10. Draft EIS Section 7 Existing Marine Environment

10.1 Section 7.2 Physical Environment

10.1.1 Section 7.2.3 Bathymetry and Seabed Features

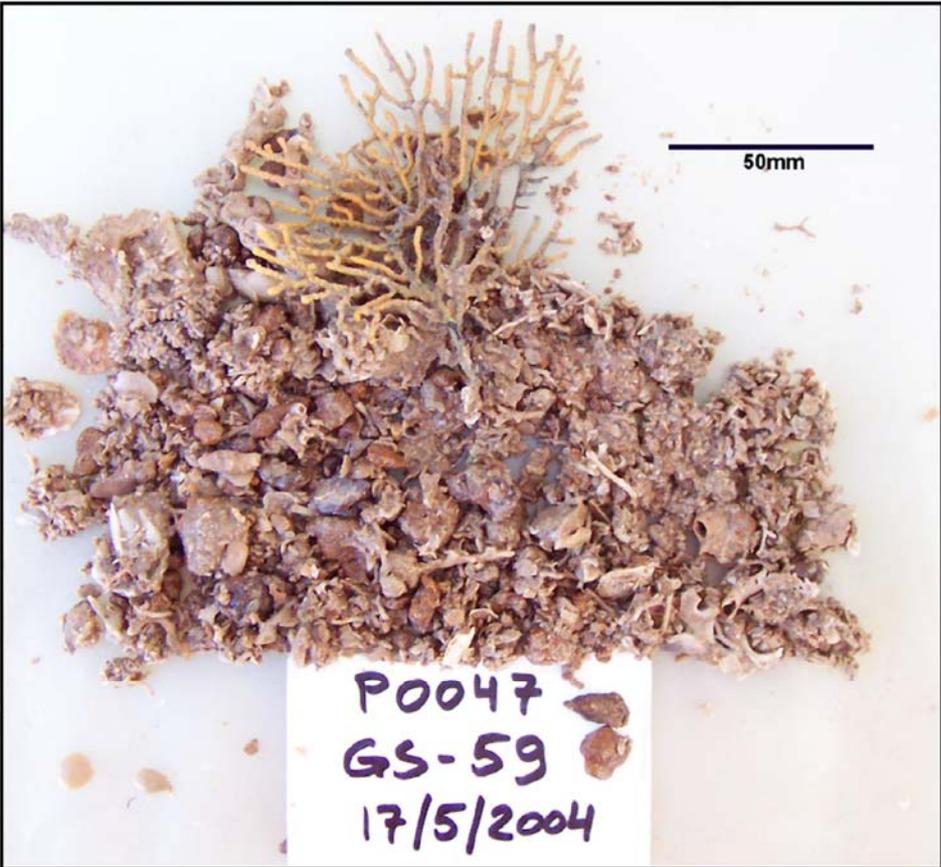
NTG 71: What will be the expected location of the cargo vessel anchors forward or to the rear of the swamp mooring?

NTG 71a: What will be the expected location of the cargo vessel anchors forward or to the rear of the export mooring?

The cargo vessels anchors will be north of the condensate export mooring.

■ **Figure 13 Projected Average Annual Mass Of Hydrocarbon Discharge over the Lifetime of the Field (Assuming 30mg/l)**

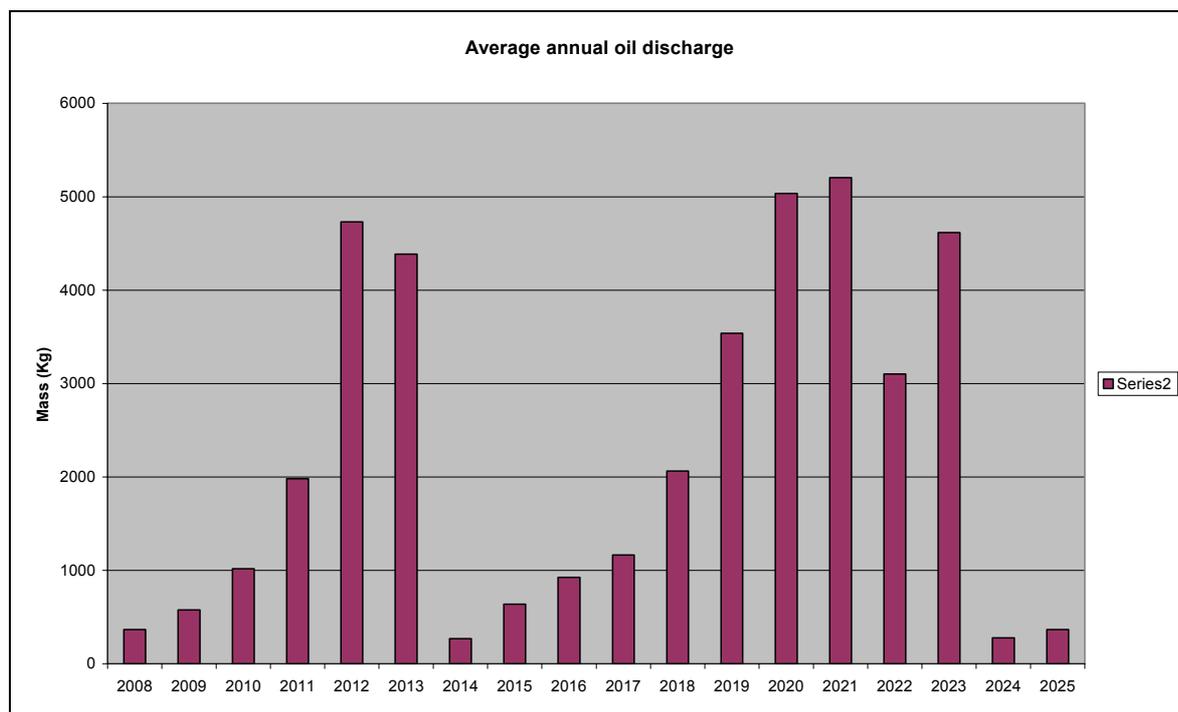
OEH 33: The Draft EIS forecasts that produced water (PW) “may produce an oily sheen which has a visual impact” (Section 11.18). This is undesirable as there is a high potential for marine food resources to become tainted. Modelling results further suggest that pollution may initially move away from the coast but return on the following tide; the Supplement should therefore investigate scenarios in which the discharge point is further out to sea (Figure 11.3, Section 11.19.1). Dispersion has perhaps been overstated as a mechanism throughout the report given the pulsing currents in this tidal area.

Figure 13 shows the average annual mass of oil discharged over the lifetime of the field. This was calculated from the projected discharge rate assuming an average oil concentration of 30 m/l. As can be seen, in the first year approximately 360 kg will be released. This increases to approximately 4700 kg in 2012.
